INSIDE OUT PAINTING AND REMODELING

SITE PLAN

SP# 07-24

STAFF REPORT

INFILTRATION TRENCH CROSS SECTION
NOT TO SCALE

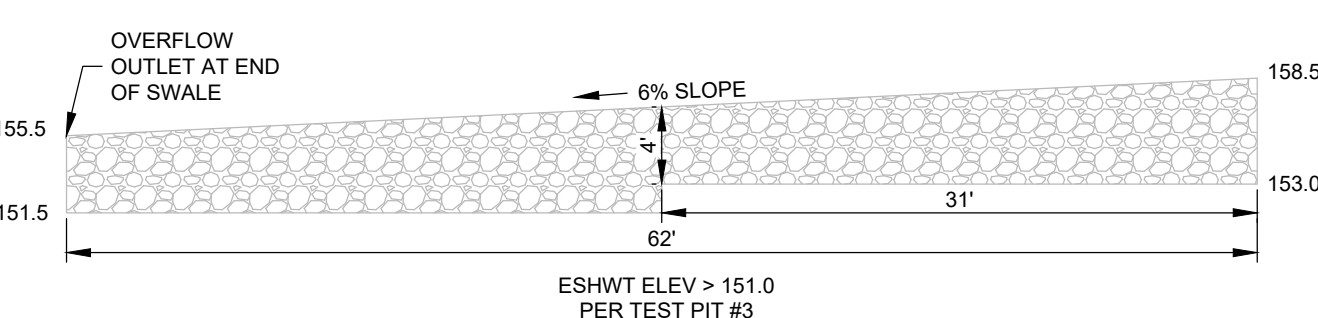
g. HR 275-5.A.(11). The applicant should provide additional information as to the design intent of the Infiltration Trench Cross Section Detail upon Sheet 9. It is uncertain if the detail is intended to have filter fabric line the perimeter of the stone. It is recommended filter fabric be noted to ensure the lifespan of the drainage feature. Also please provide additional information on the "observation well, with screw top lid" illustrated, including but not limited to material, size, height below grade, height above grade, perforated/solid, etc. Is this vertical well port connected to a horizontal pipe element of the design? If so, additional information is required.

See revised Infiltration Trench Cross Section detail on Plan Sheet 8.
